by Jonathon Williams

Course: BSc (Hons) Electrical & Electronic Engineering
Module: SGEL6000 Independent Project
Assignment: 2. Project Design, Implementation and Evaluation
Name: Jonathon Williams
University Number: 1708159
Date Submitted: 06/05/2022
Word Count: 5823

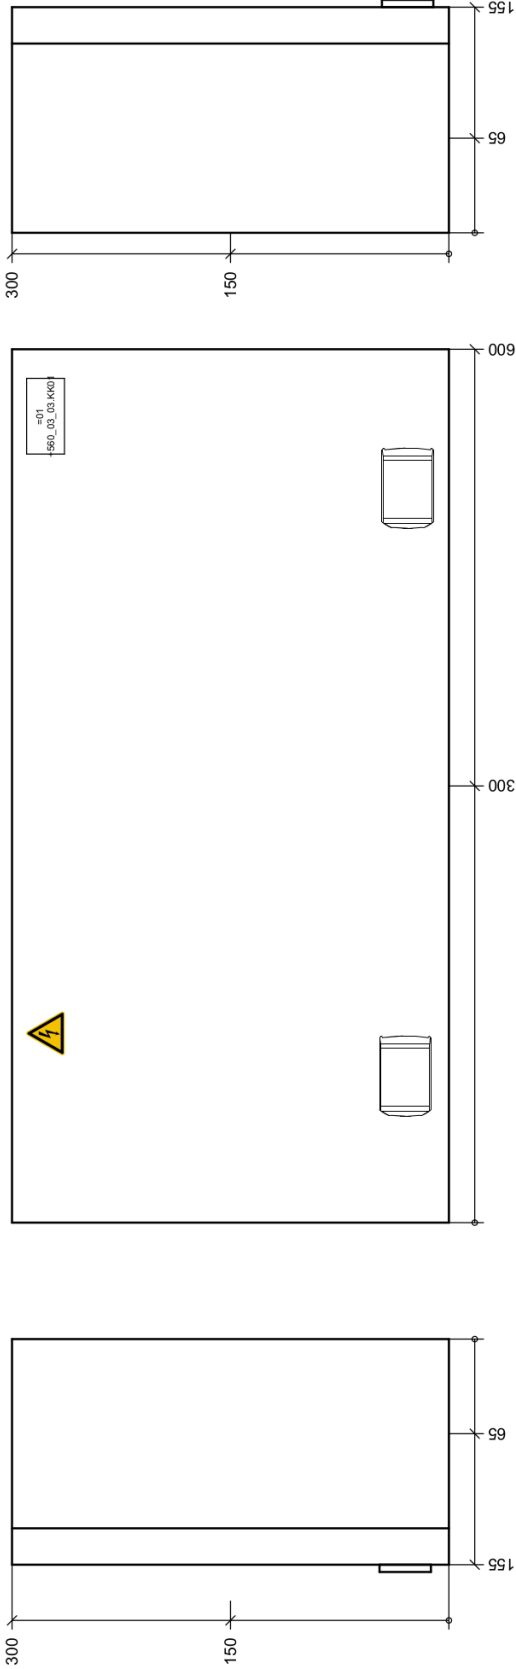
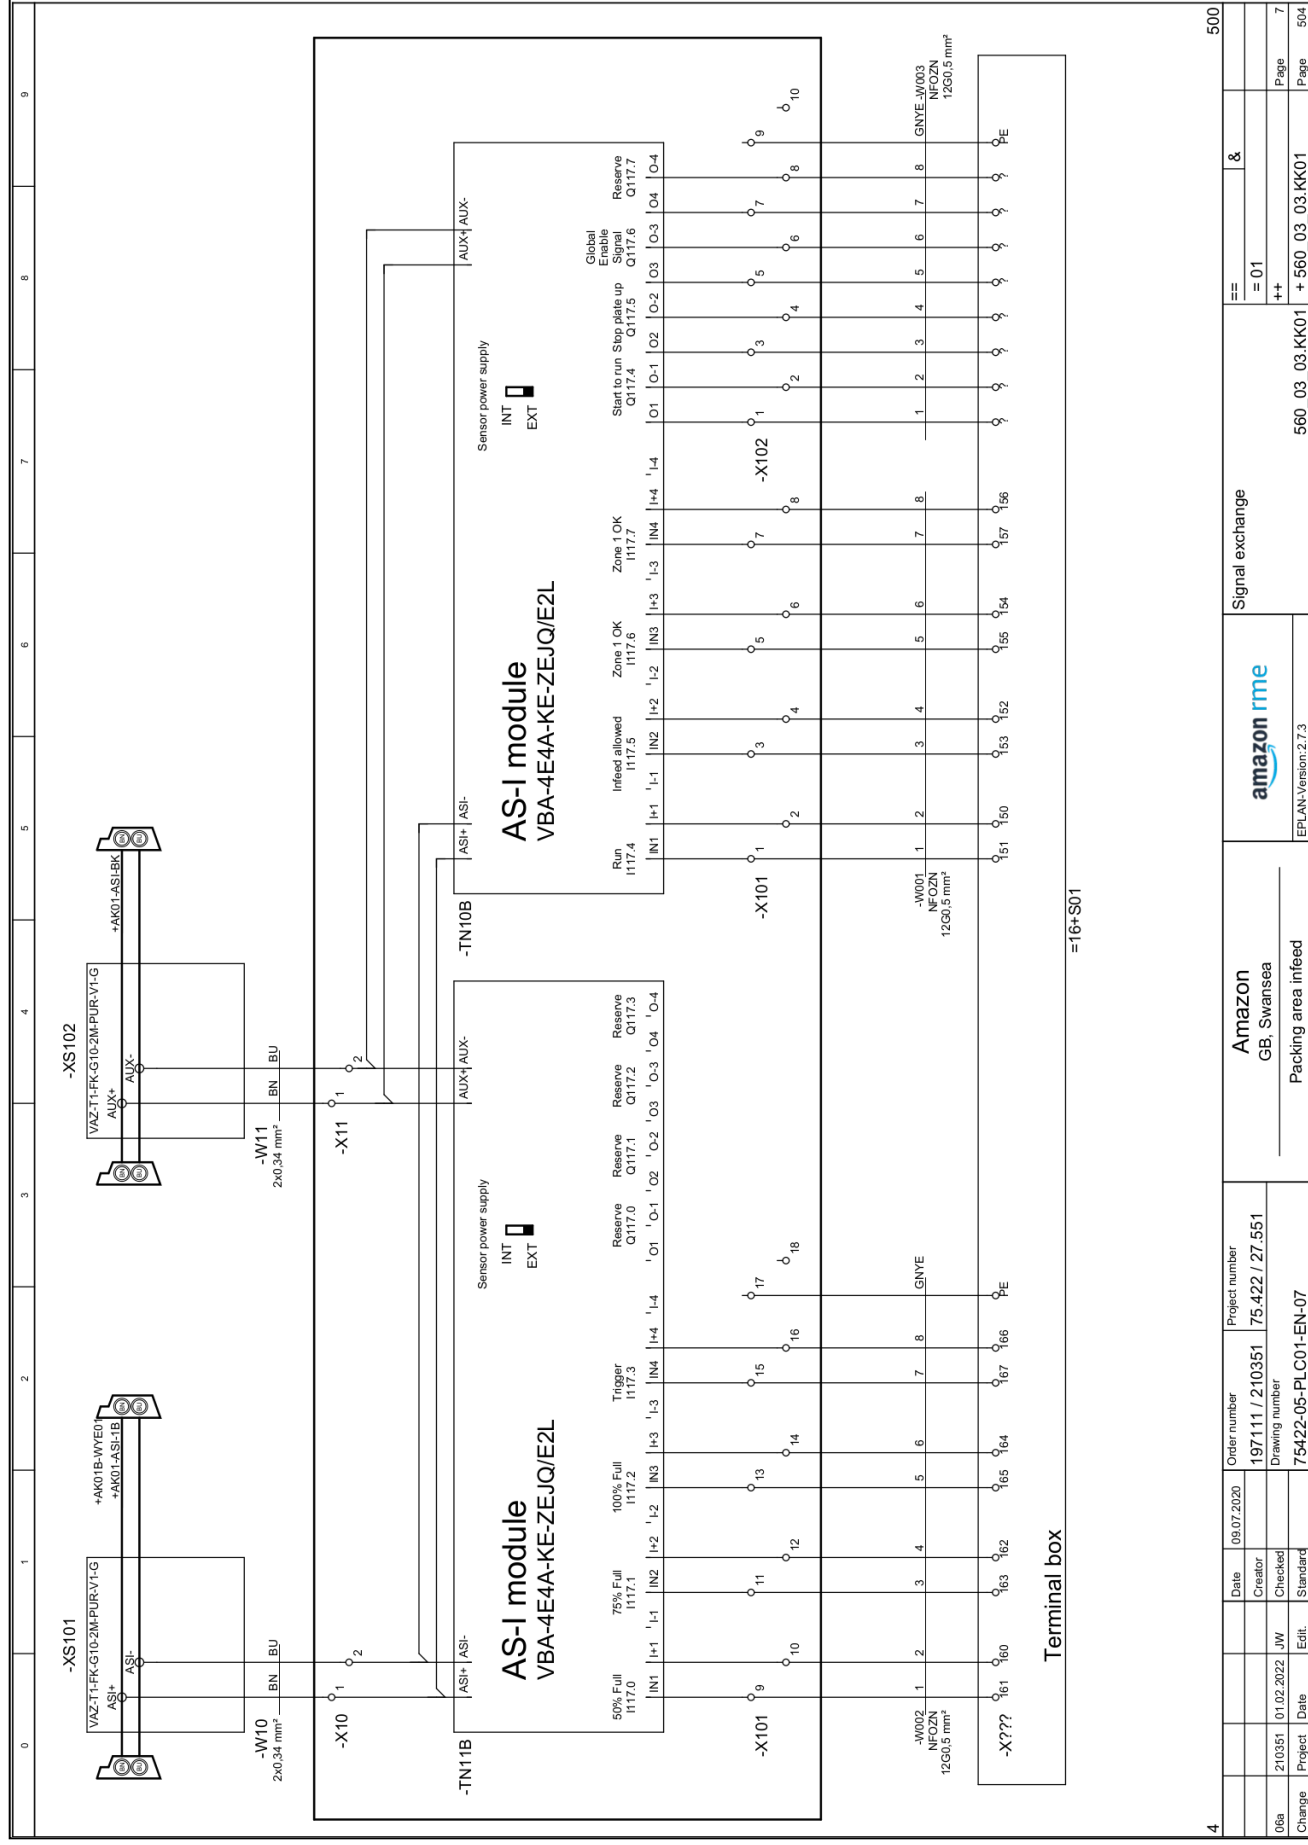
All figures in the appendix could have been numbered and referenced and explained in the text of the report.

This is meaningless without an explanation and is lacking in detail.
